CERTIFICATE OF APPROPRIATENESS STAFF REPORT

I. CASE NUMBER(S): P13-0889

- 1) **Proposal:** Proposed Certificate of Appropriateness for a new 1,548 square foot single family residence with detached garage on a contributing lot to the Wood Streets Neighborhood Conservation Area that was recently split off from the original lot with an approved parcel map within the R-1-7000-CR (Single Family Residential, Cultural Resources Overlay) Zone and Wood Streets Neighborhood Conservation Area.
- 2) **Location:** 4411 Elmwood Court, located 300 feet east of Palm Avenue.
- 3) **Applicant:** Michael W. Cote on behalf of Riverside Marcus LLC
3975 Madison
Riverside, CA 92504
- 4) **Case Planner:** Teri Delcamp, Historic Preservation Senior Planner
(951) 826-2117
tdelcamp@riversideca.gov

A2

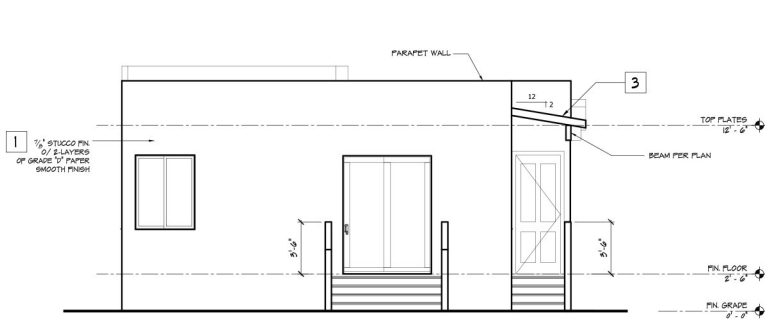
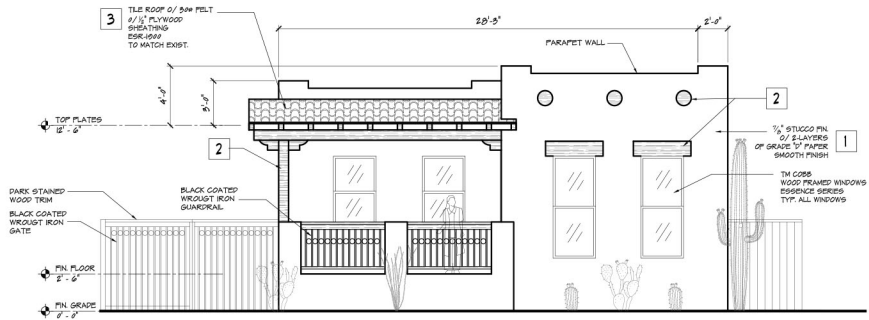
The applicant responded to staff’s inquiry that the owners agree to a condition that requires two-piece, or single barrel, clay tiles instead of the proposed concrete S-tiles. The clay two-piece tiles are more compatible with the historic materials of the NCA and will be more visually consistent with the clay pipe roof vents proposed on the front façade. Staff is also

- b. Plans shall specify that the three circular features below the parapet on the front façade are clay pipe drains/vents.
 - c. Plans shall specify that the material for the two shed roof elements shall be two-piece, single barrel clay tile.

LANDSCAPE PLAN

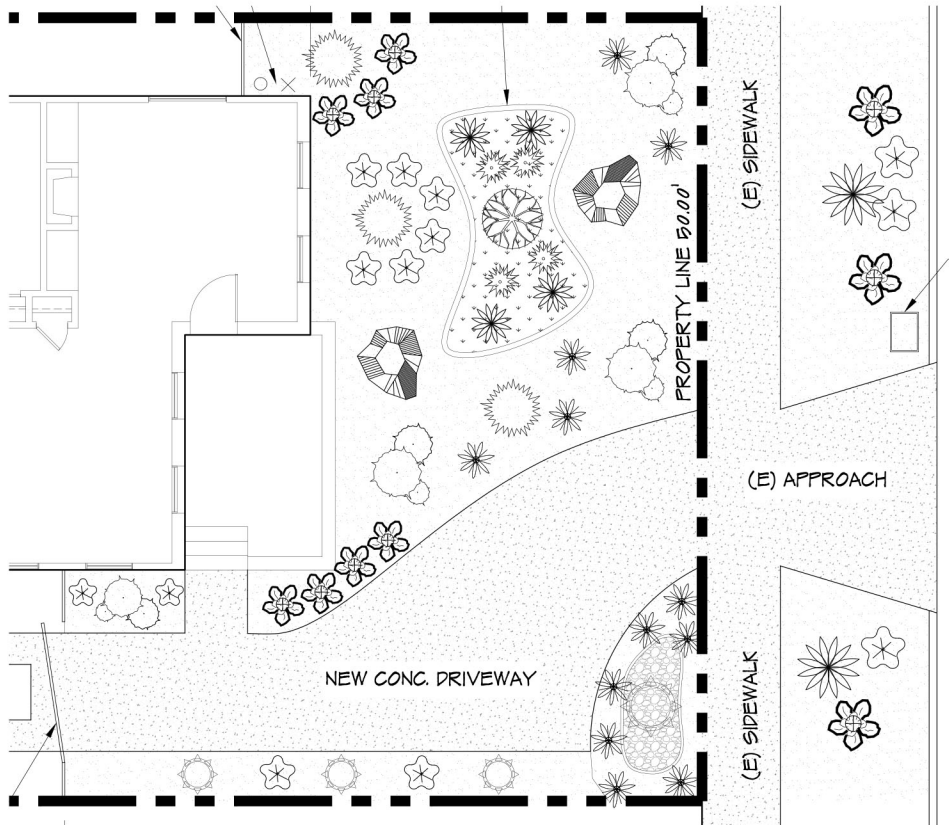
suggesting that gray concrete be used for the new driveway consistent with the Design Guidelines and historic period appearance, although staff does note that the proposed “Saltillo Tile” concrete stain is a warmer color compatible with the proposed decomposed granite in the front yard, and will defer to the CHB’s preferences.

- d. Unless otherwise approved by CHB staff, the driveway shall be gray concrete with historically appropriate scoring, without any modern finishes or added colors.

- e. The project shall protect in place and re-use the existing driveway approach including its location, width, material and design; or if required to be relocated by Public Works, shall be re-constructed to match the existing in all these respects. The existing mature tree and street lamp shall be protected in place.
